ADDENDUM 04

Issued: April 24, 2024

RE: Boney Courthouse Generator Replacement, ANC-C-2024-0005

MECHANICAL
SCHEDULES AND
SCHEMATICS

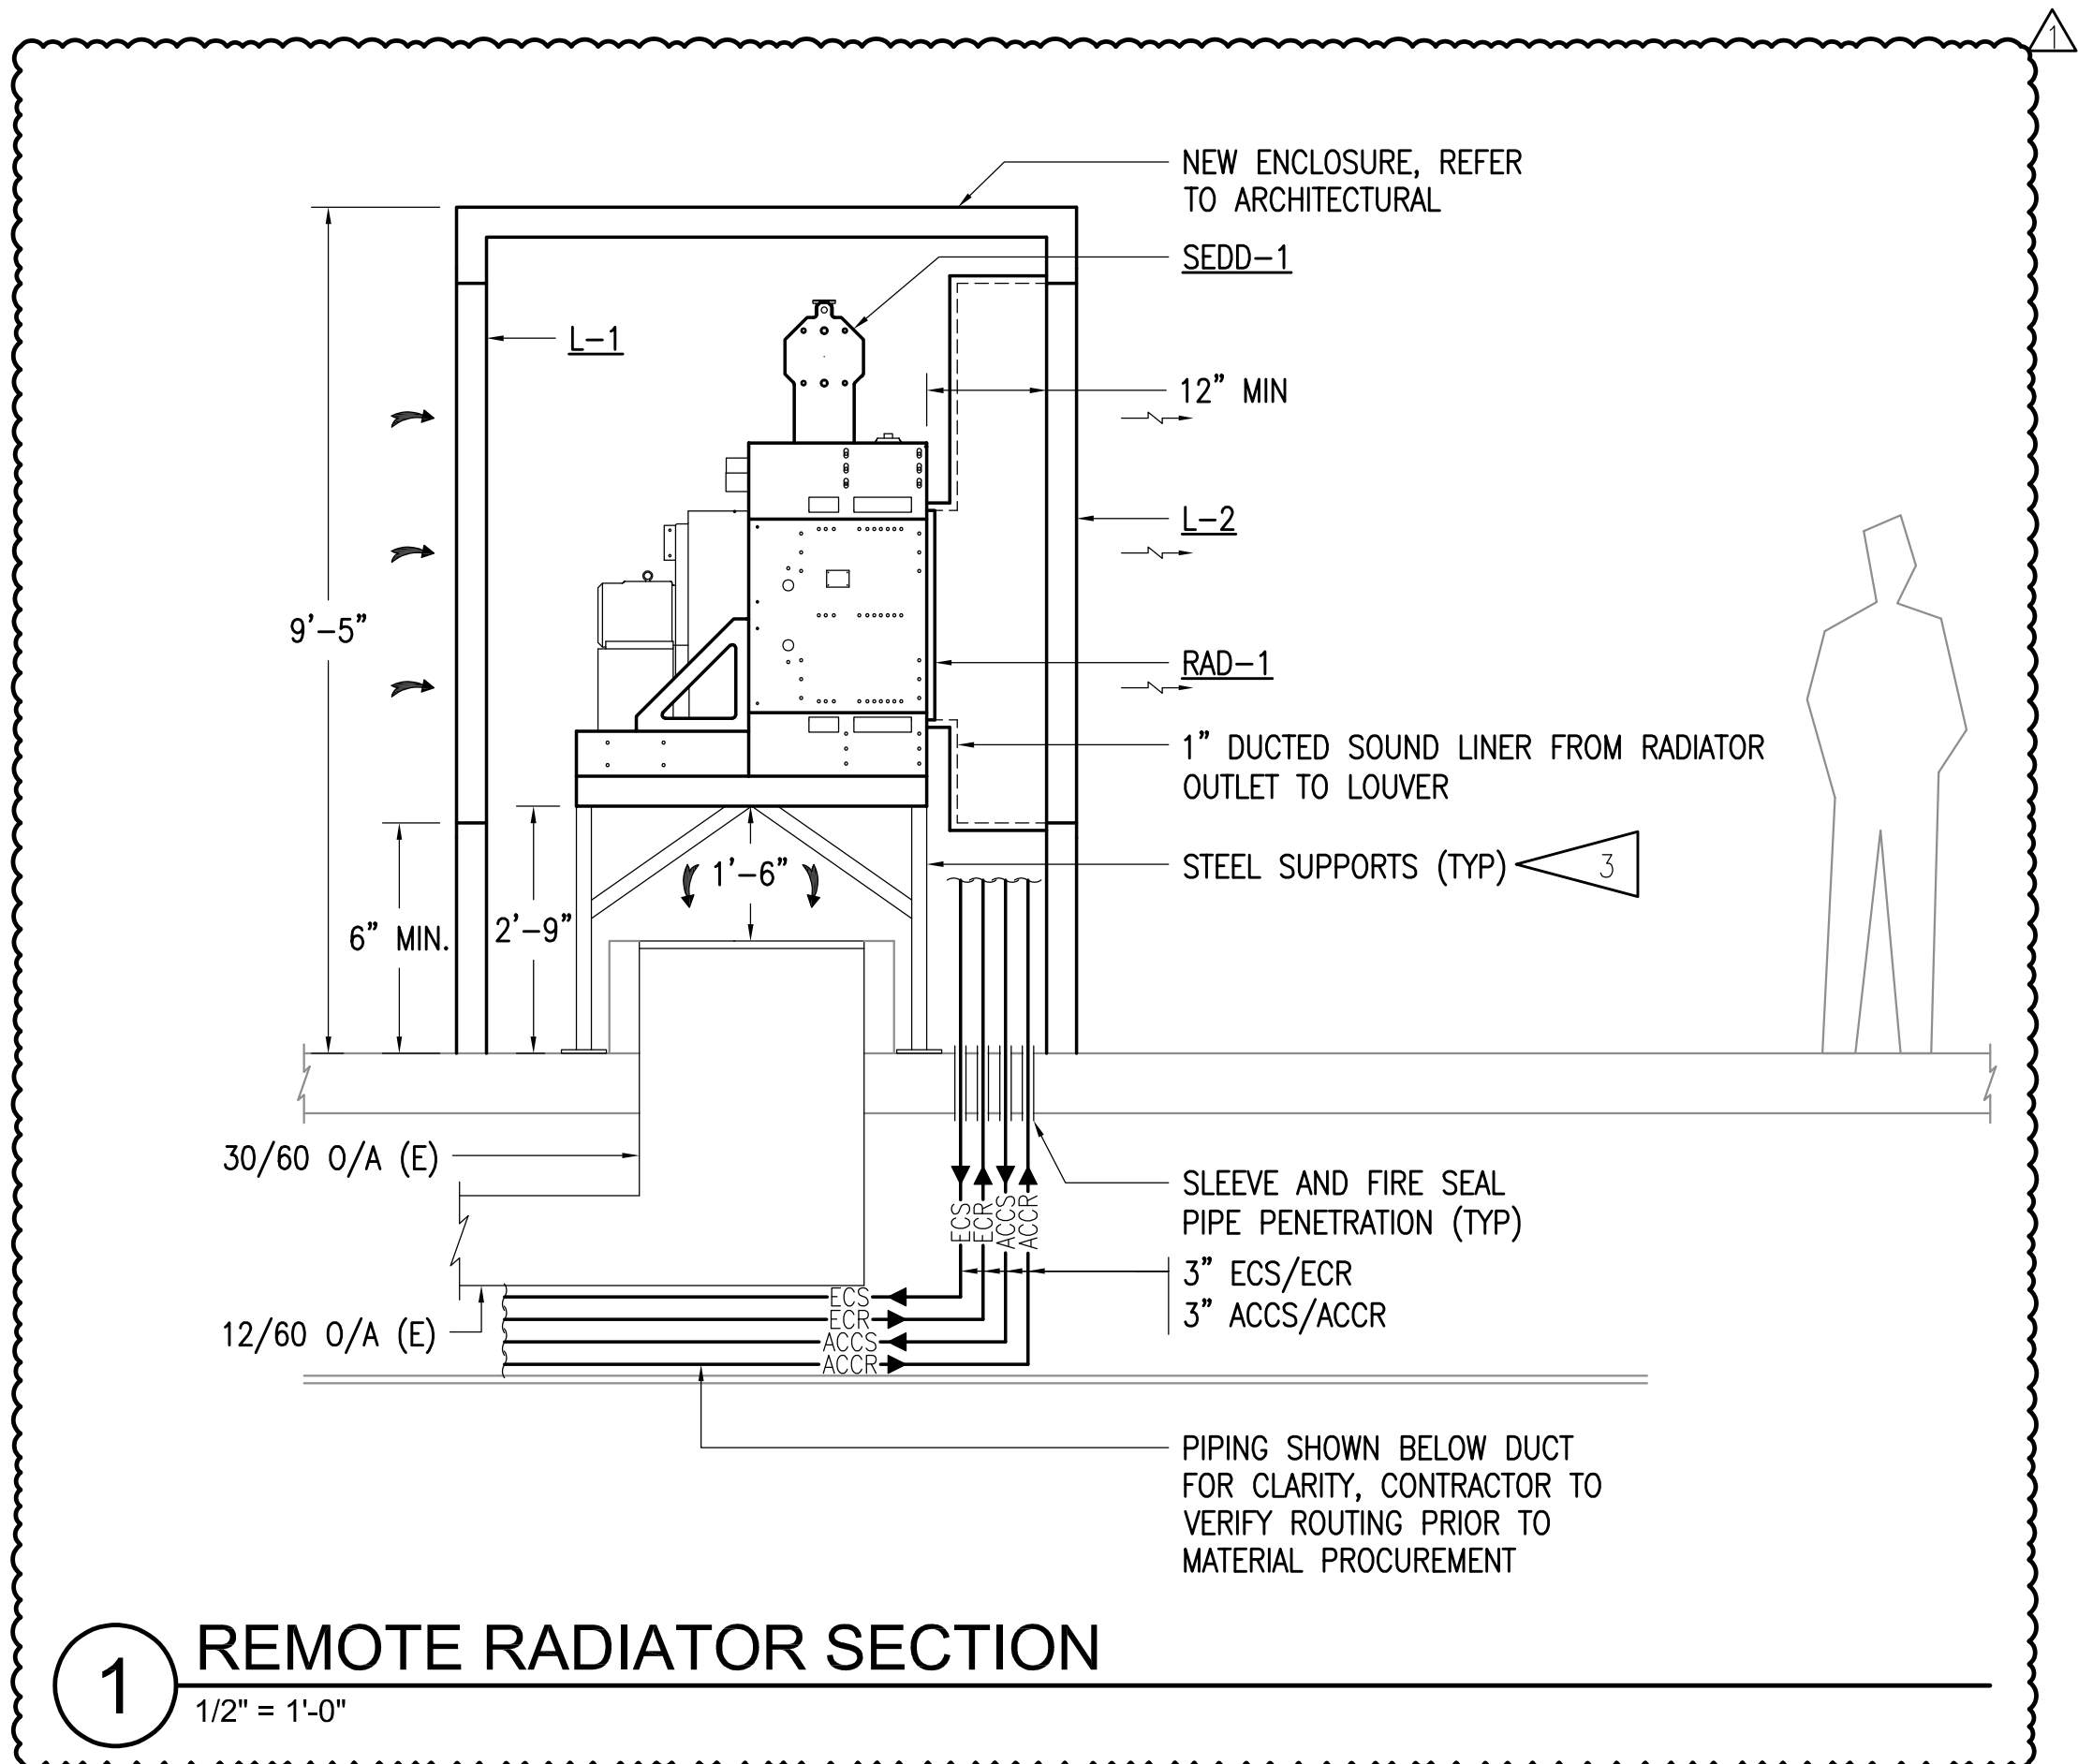
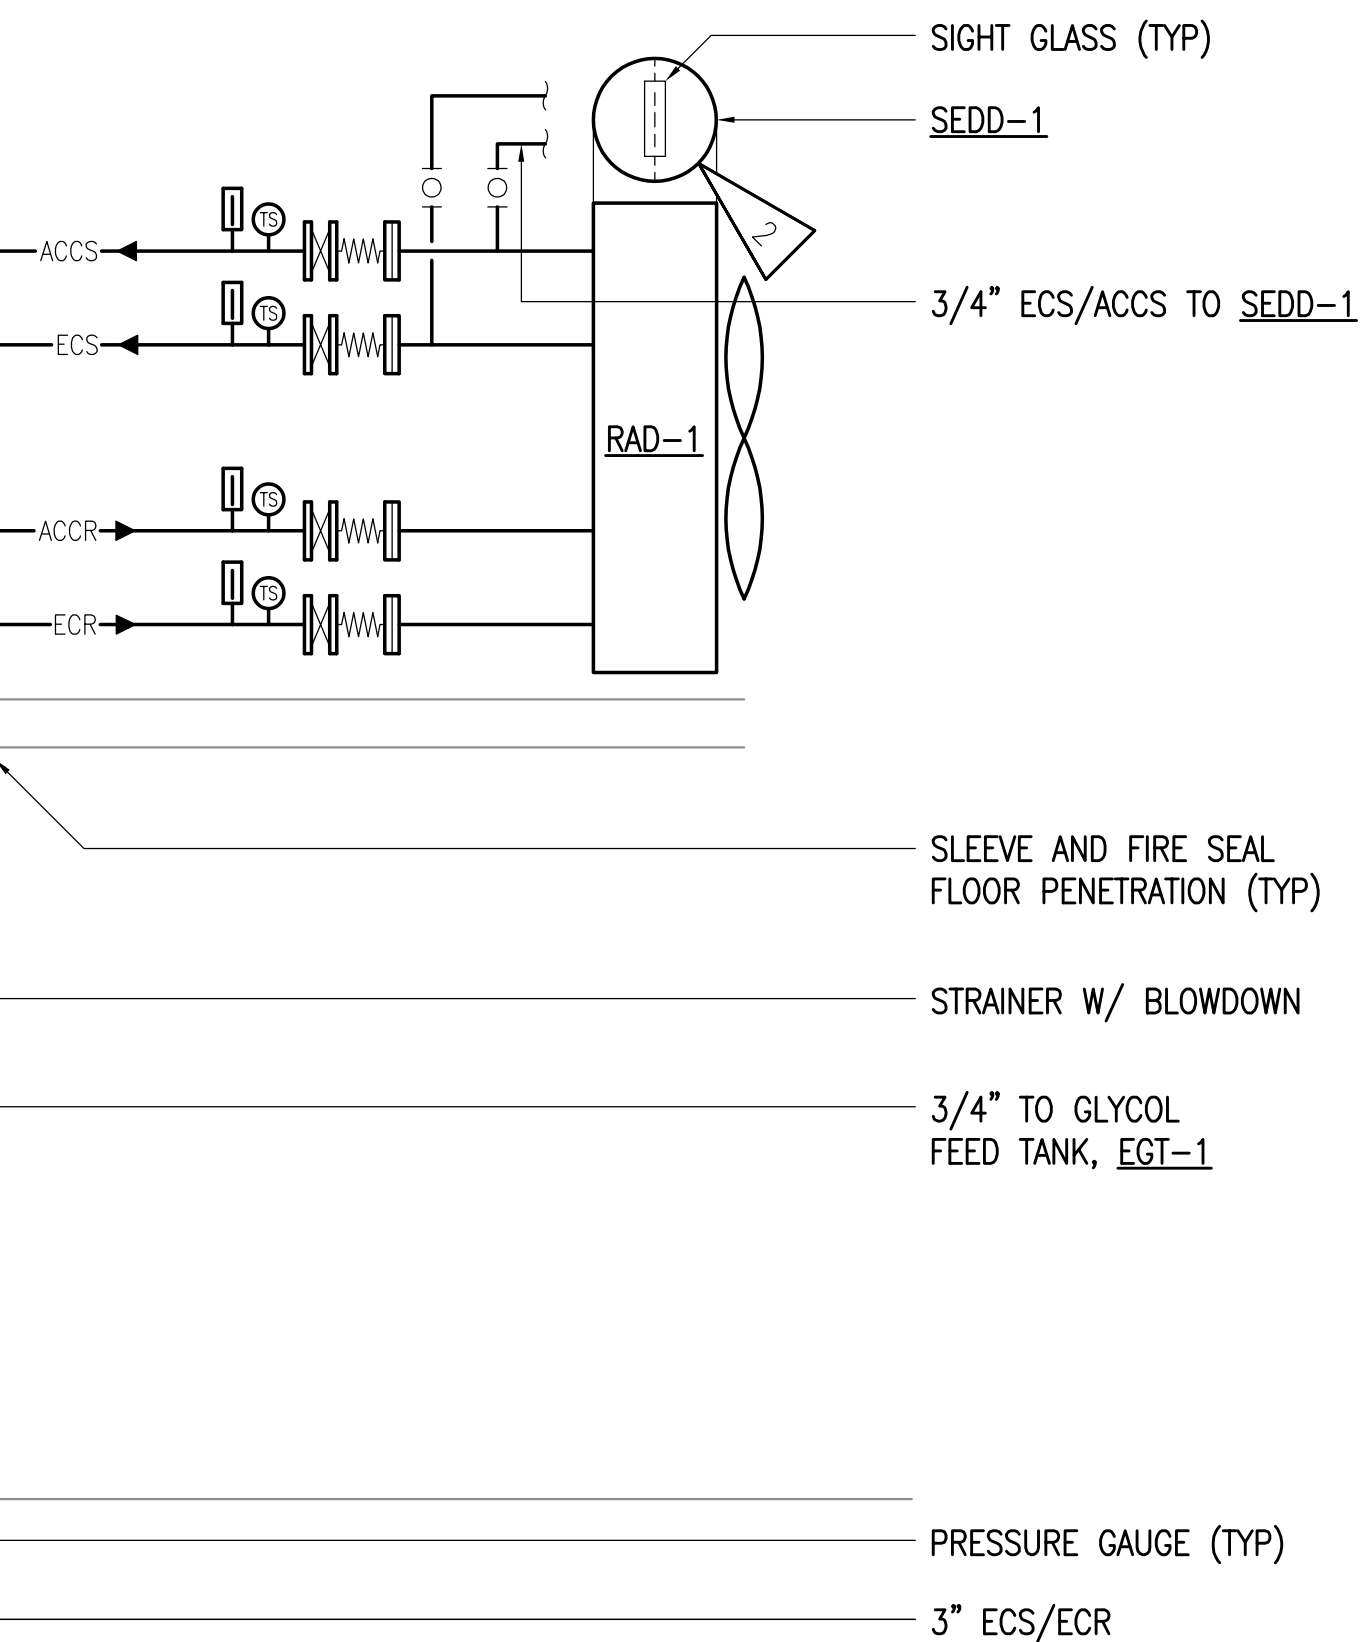
Sheet M301 is REVISED per attached.

29. Question: *Schematic note 4 on sheet M301 states to coordinate with owner for procurement of masonry wall fascia. What coordination is this referring to, just finish look/color coordination?*

33. Question: *Referencing M301, do we have to provide low level sensors?*

Response: Refer to Architectural sheet added to the Drawings under this addendum.

Response: Yes. Sensors are required for coolant monitoring by the generator. All wiring to be done by the electrical contractor.

**LEGEND,
ONE-LINE
DIAGRAMS, AND
LOAD
CALCULATION**

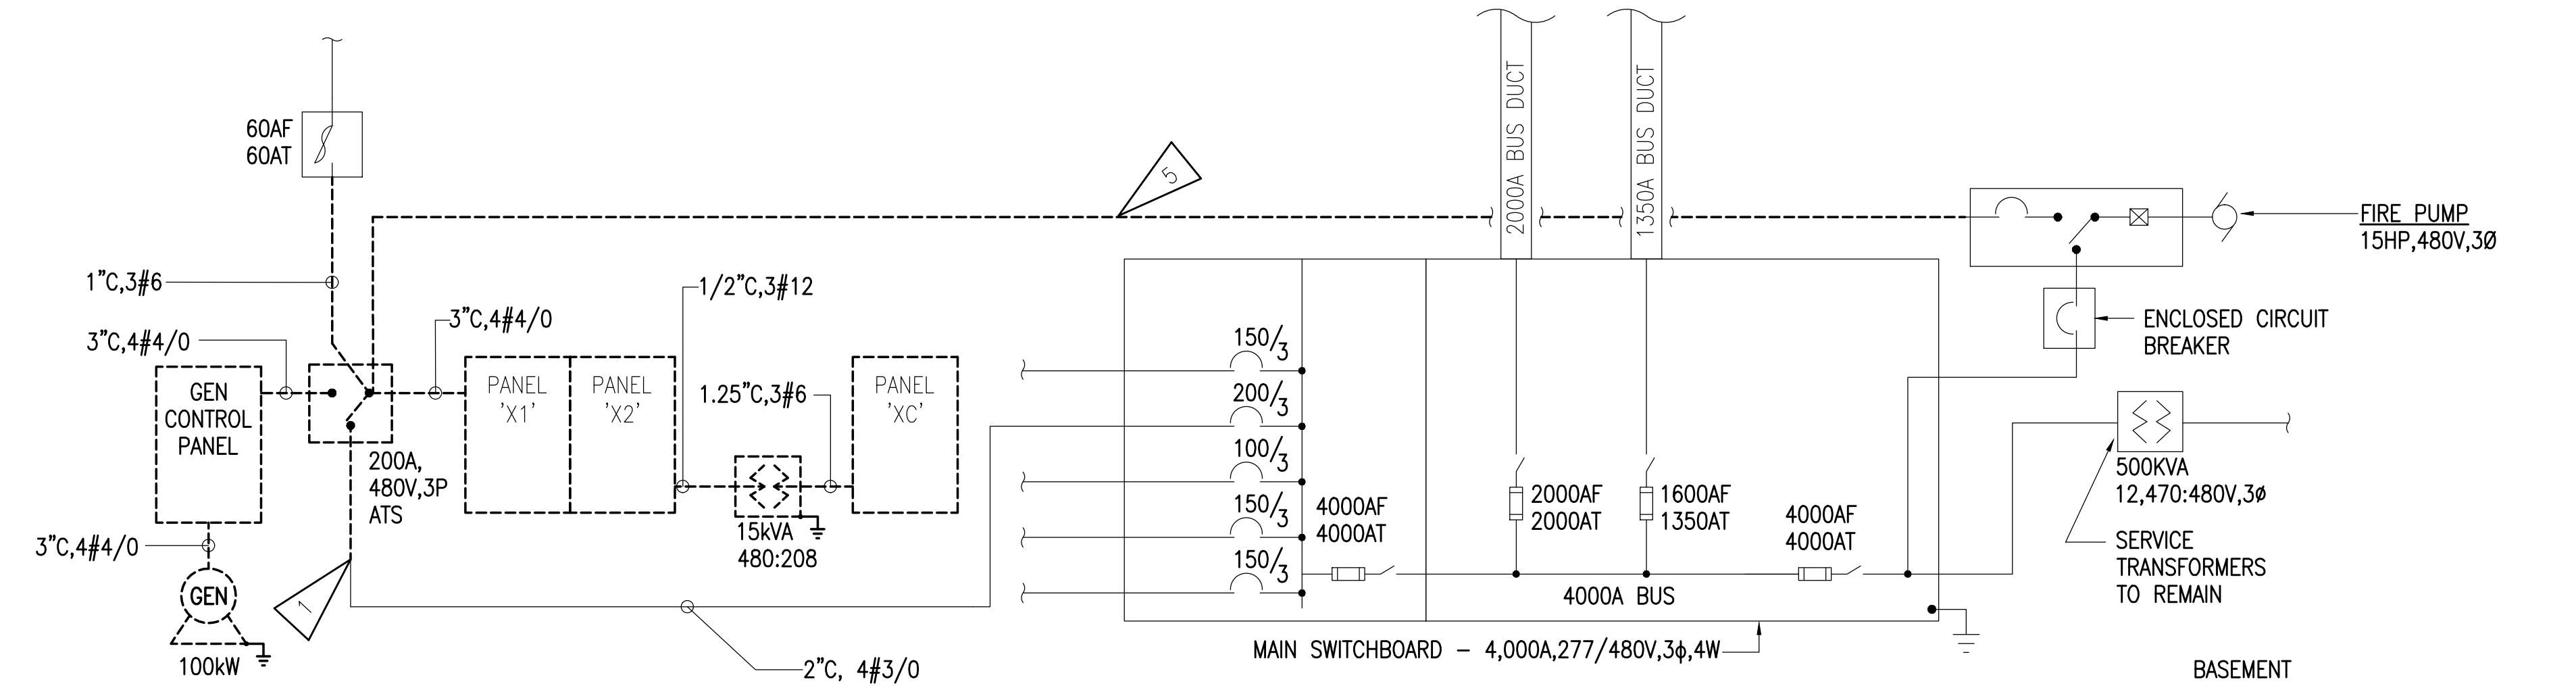
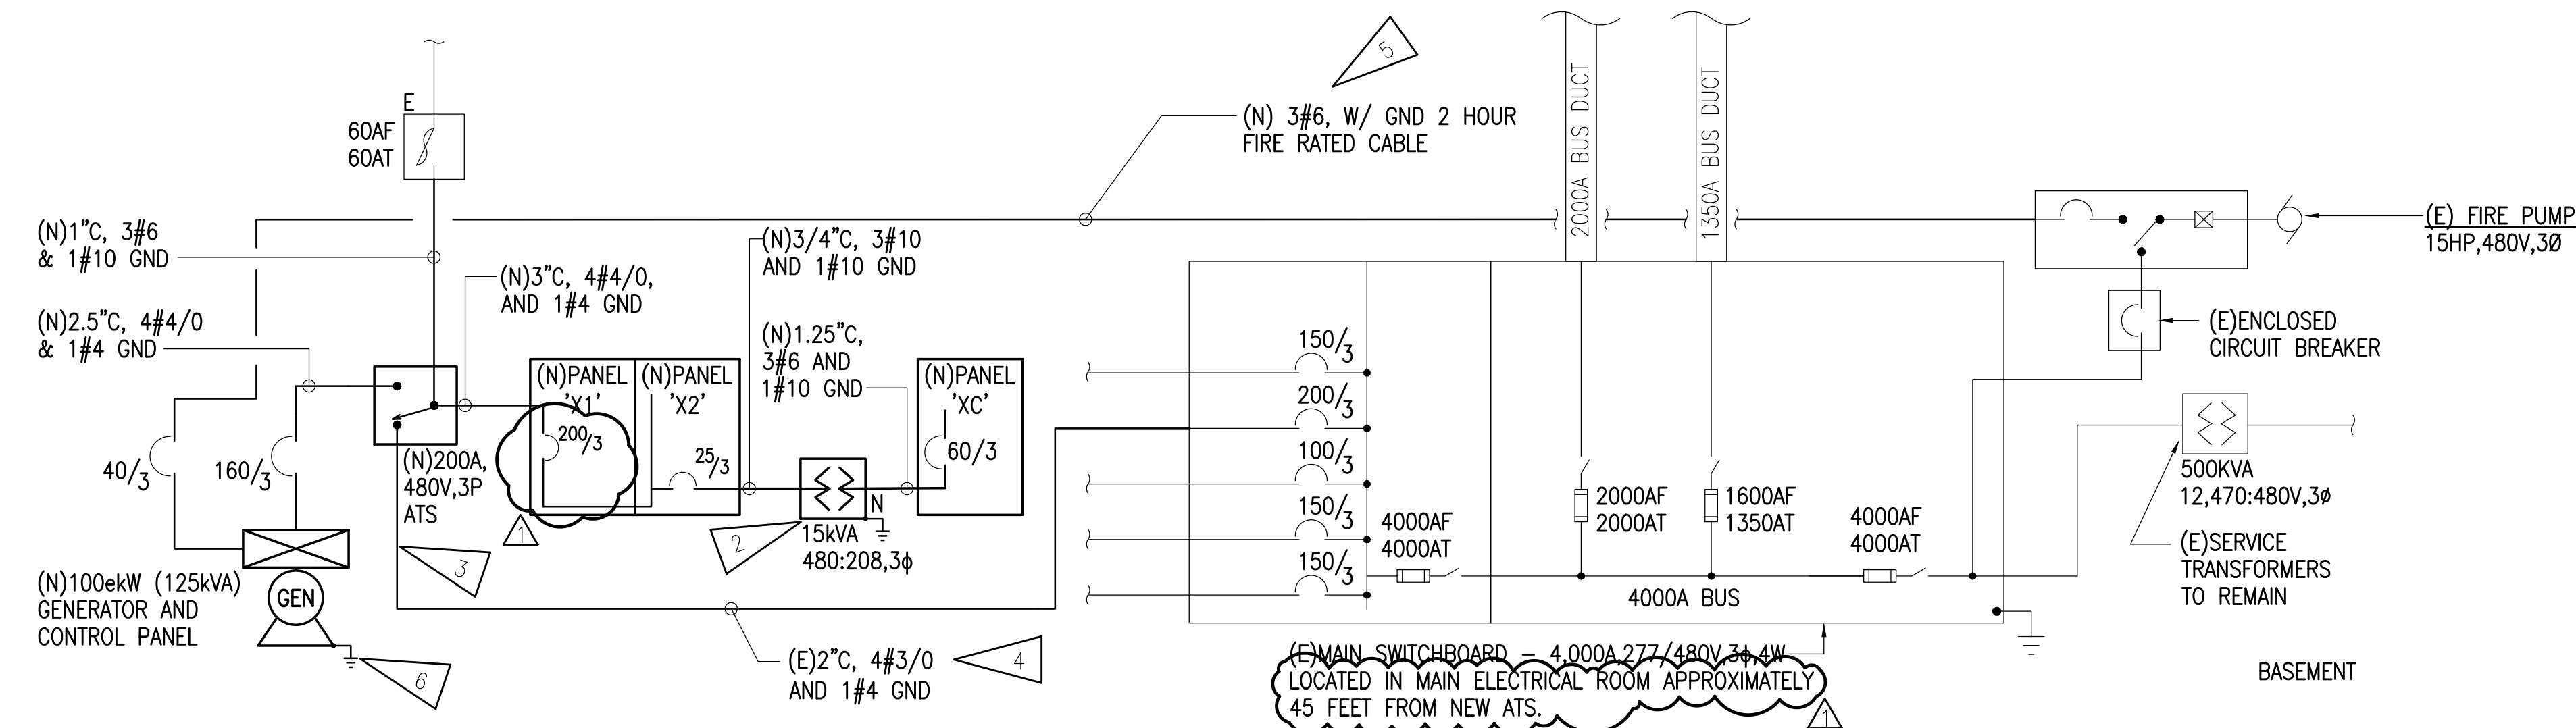
Sheet E001 is REVISED per attached.

35. Question: *Drawing E001 & E301 – Panel X1 panel schedule indicates main breaker and the see one-line for size. One-line does not show main breaker size for Panel X1. Please provide main breaker size?*

37. Question: *Drawing E001 – Sheet note #4, please provide location of Main Switchboard in reference to this project.*

Response: Provide a 200A, 3-pole main circuit breaker.

Response: Main switchboard is across the hall in the electrical room.
